**ORDINARY COUNCIL MEETING
9 NOVEMBER 2021**

13.2.4 PROPOSED AMENDMENT TO SOUTHERN RIVER PRECINCT 3C (SOUTH) LOCAL STRUCTURE PLAN

For Council to consider endorsing a proposed amendment to the Southern River Precinct 3C (South) Local Structure Plan at 1793, 1794 and 1795 Matison Street, Southern River.

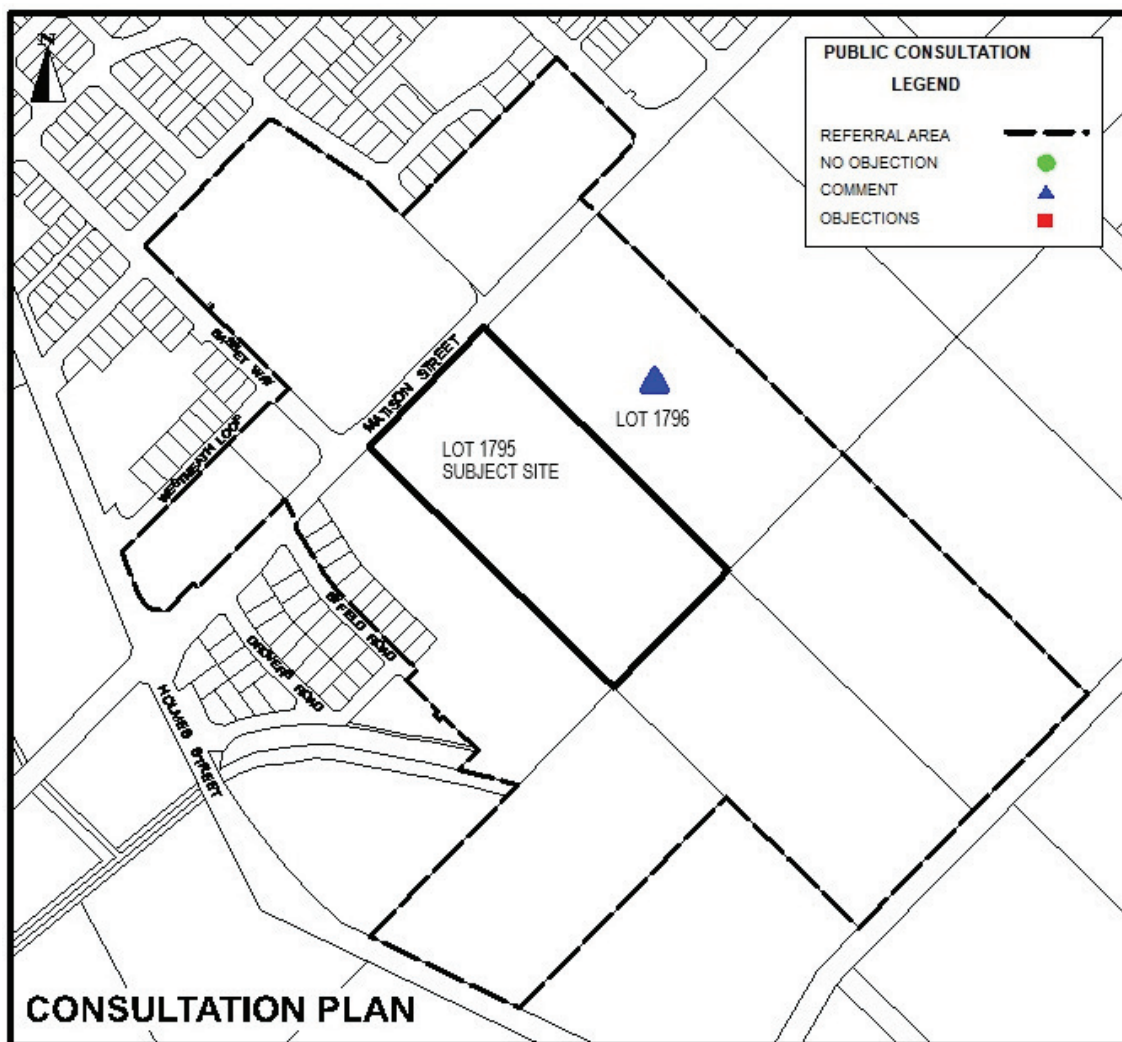
Concern / Matter Raised	Technical Response
The buffer area was not supposed to be touched. They have replaced all the original Bassendean Sand with contaminated and dirty sand from across the site.	The clearing of the wetland buffer is currently being investigated. The filling activities and removal of soil / vegetation that has occurred within the buffer area will need to be addressed and resolved in the Wetland and Wetland Buffer Management Plan.
Mulch has been spread over the buffer area. There is castor oil and bamboo mulch in the mixture that has been spread. Neither of these are native to the region. They are also not in the declared weed list. They need to be removed before they spread to neighbouring properties. This cannot be done with chemical sprays.	Weed control obligations are established in the Wetland and Wetland Buffer Management Plan. Prior to accepting management of the wetland buffer, the City would ensure that the area is free of weeds to an acceptable standard.

Owners of Lot 1796 were told to expect a 50m buffer, and took that into account when planning the layout of the property.	Noted, however the dwelling on the Lot 1796 was constructed within an existing cleared area which provided a logical location of the dwelling considering the CCW present on the property. Revegetation works within the proposed 30m buffer area can be undertaken providing significant screening opportunities between the subject land and Lot 1796.
The tube stock that is being used to replace the vegetation that was removed from the original buffer area is not sufficient to replace the mature trees that were destroyed. To destroy natural vegetation and replace it with one tree per 10 square metres is not good enough.	When considering the revegetation of the Wetland Buffer the inclusion of advanced trees (i.e. minimum 1 – 4 metre tall) can be required so as to provide immediate height in the revegetation area.

On the proposed development plan there is a track through the buffer zone. According to the original plans there would be no access to the buffer zone.	The track has been provided for maintenance, fire management purposes and walking trails.
The buffer area originally consisted of diverse flora. Is this going to be replaced in a like manner? Or will it be a single variety planting?	Species composition and diversity will be stipulated in the Wetland and Wetland Buffer Management Plan. The revegetation of the buffer will provide for species diversity found in the locality.

- The Environmental Protection Authority's *Guidance Statement 33 Environmental Guidance for Planning and Development (2008)* recommends that 'all Conservation category wetlands and appropriate buffers are fully protected' and that 'wetlands that are to be protected require a minimum 50 metre buffer distance'. The proposed 30m buffer distance is non-compliant with the EPA's guidance statement.
- The adopted stormwater management strategy included discharging treated stormwater into the CCW through the 50m vegetated wetland buffer. A significant reduction in the buffer width would not comply with the adopted

stormwater management strategy. DBCA notes that an updated Local Water Management Strategy was not provided as part of this amendment.

No.	Recommended Modification and/or Information Requirement	Reason(s)
1.	The width of the buffer to the CCW to be amended to be 30m where it adjoins the property boundary with Lot 1796 Matison Street and 50m in width where it adjoins the property boundary with Bush Forever Site 464, and where required, the structure plan map be updated.	To address the City's assessment of the proposed amendment.

2.	Updating the Local Structure Plan text to reference a 30m wetland buffer to the property boundary with Lot 1796 Matison Street, and a 50m wetland buffer to the property boundary with Bush Forever Site 464.	To ensure the Local Structure Plan map and text are consistent.

3.	Endorsement of the Wetland and Wetland Buffer Management Strategy by the City.	To accord with the requirements of Council Policy 6.2.2 - Rehabilitation and Revegetation of Natural Areas.

4.	The submission of an updated Local Water Management Strategy to support the amendment to be endorsed by the City and the Department of Water and Environmental Regulation.	To provide a broad drainage strategy for the site so as to inform any future detailed drainage strategies forming part of the subdivision proposals.
